Transport
for NSW

Barangaroo Ferry Hub

Submissions Report

Figure 3 - Indicative wharf and landside layout

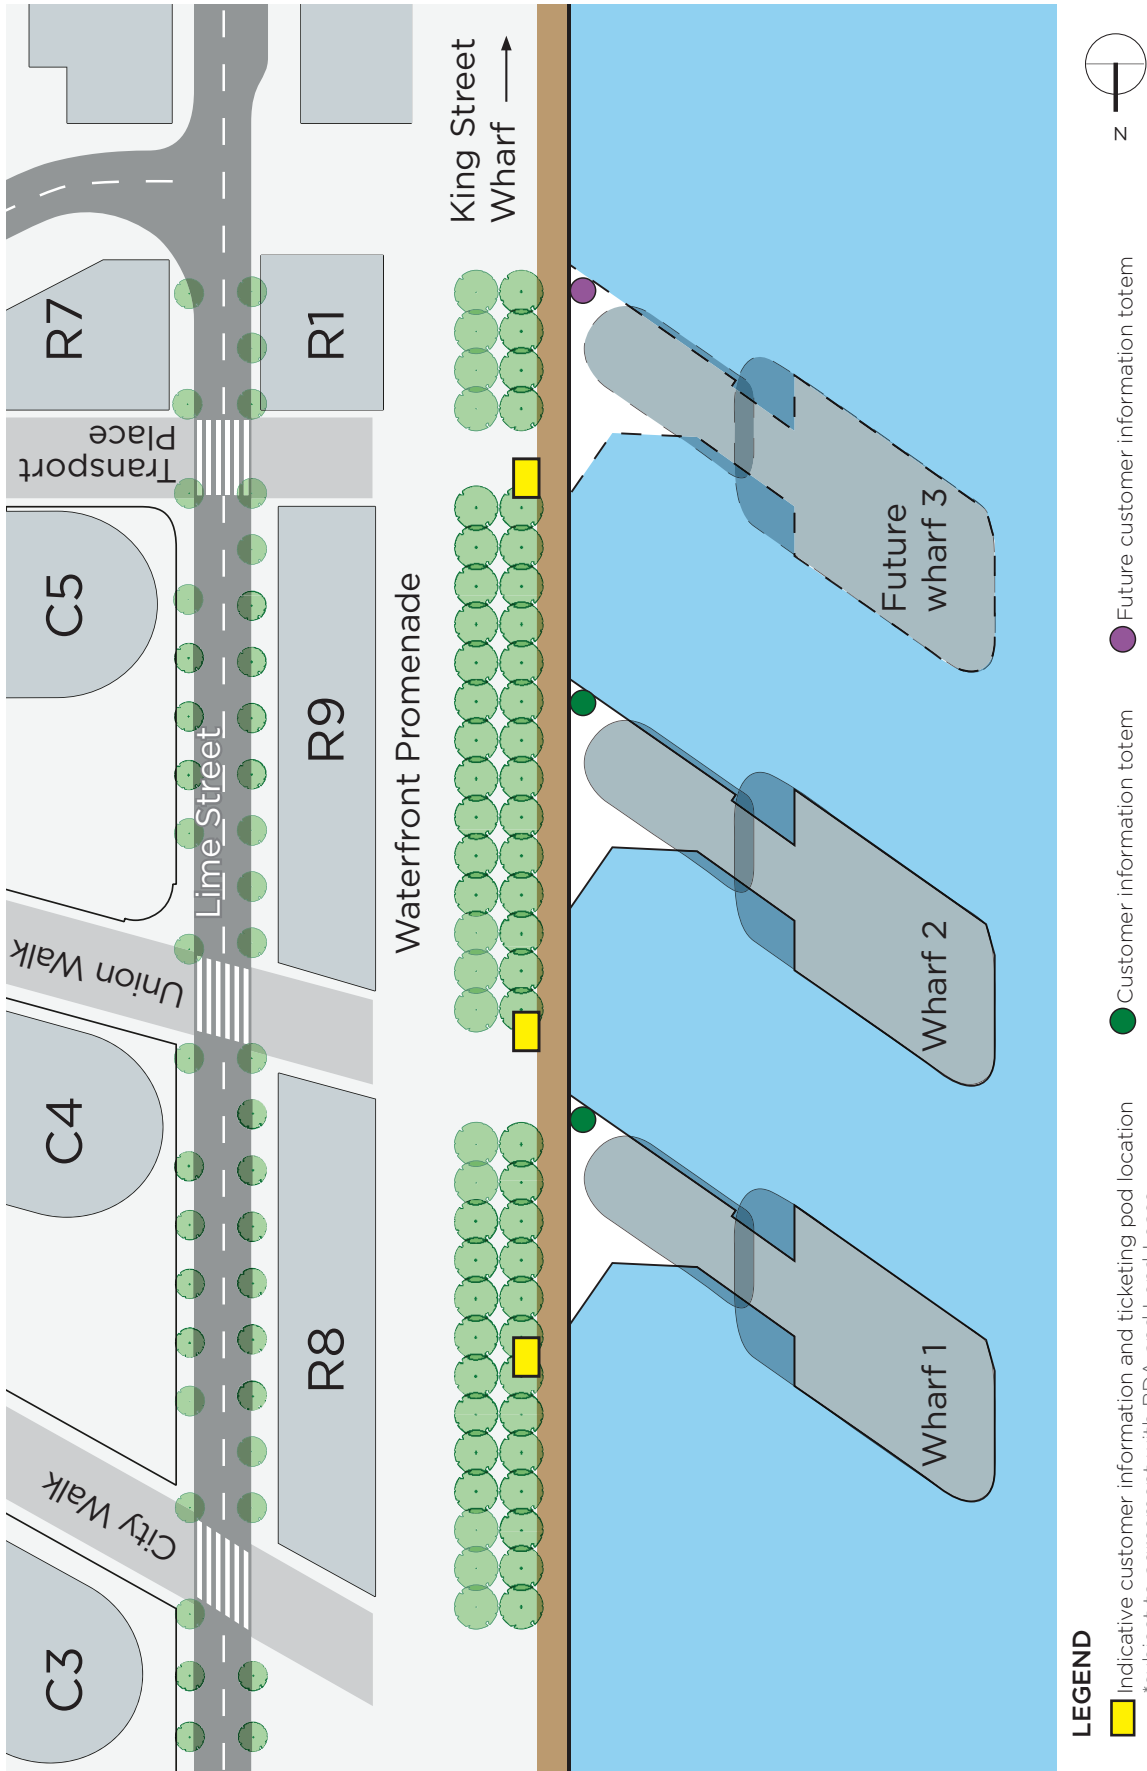
5.8e	<p>Recommends the design and location of landside ticket machines and signage be subject to approval by Lend Lease and BDA.</p>	29	TfNSW has proposed three ticketing facilities in alignment with the trees as shown in Figure 3. However, the exact location of the ticketing facilities is subject to negotiation with BDA and Lend Lease as the owner and developer of Barangaroo South. This has been an ongoing process as part of the Landside Working Group.

Following exhibition of the EIS, ongoing design refinement of the proposal has identified that the two northern wharves would be built first. This has necessitated design refinement in relation to the location of customer information and ticketing pods. Three customer information and ticketing pods would be provided on the foreshore. Figure 3 gives an indication of their proposed locations.

- The final location of the customer information and ticketing pods would be decided in consultation with BDA and Lend Lease, and would be selected to minimise the impact on the foreshore thoroughfare and visual amenity of the foreshore.

Figure 5 - Indicative wayfinding signage plan

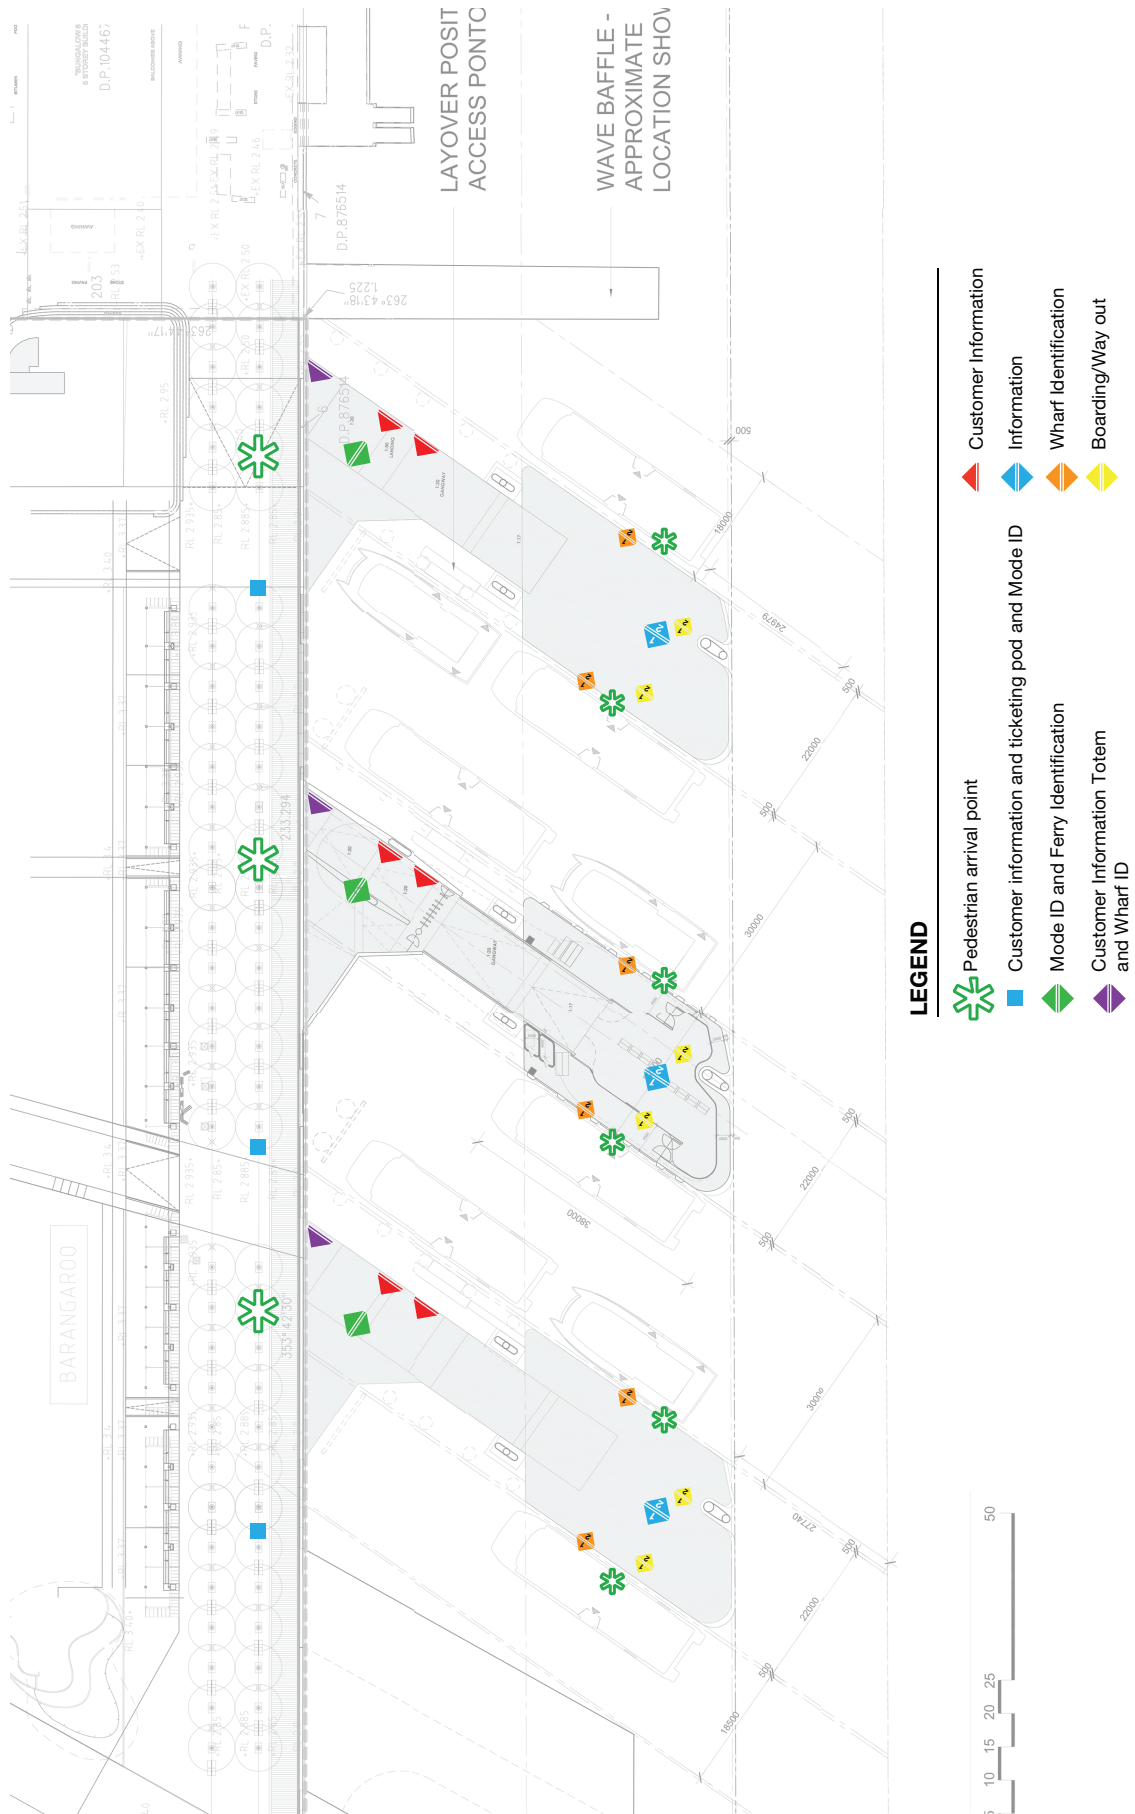
4.2b	<p>The City provided feedback on the indicative wayfinding plan including:</p> <ul style="list-style-type: none"> • Consider rationalising the number of ferry mode identifiers. Suggests deletion of two particular signs. • Consider locating ticket booths either within the zone of the wharves or on the opposite side of the boardwalk, in alignment with the trees, to minimise conflict with the path of pedestrian travel. 	<p>The TfNSW wayfinding strategy for Barangaroo Ferry Hub, including the location of ticketing devices, is undergoing design and development. This feedback from City of Sydney will be considered by TfNSW as part of this process.</p> <p>TfNSW have proposed three customer information and ticketing pods in alignment with the trees as shown in Figure 3. However, the exact location of the customer information and ticketing pods is subject to negotiation with BDA and Lend Lease as the owner and developer of Barangaroo South.</p>
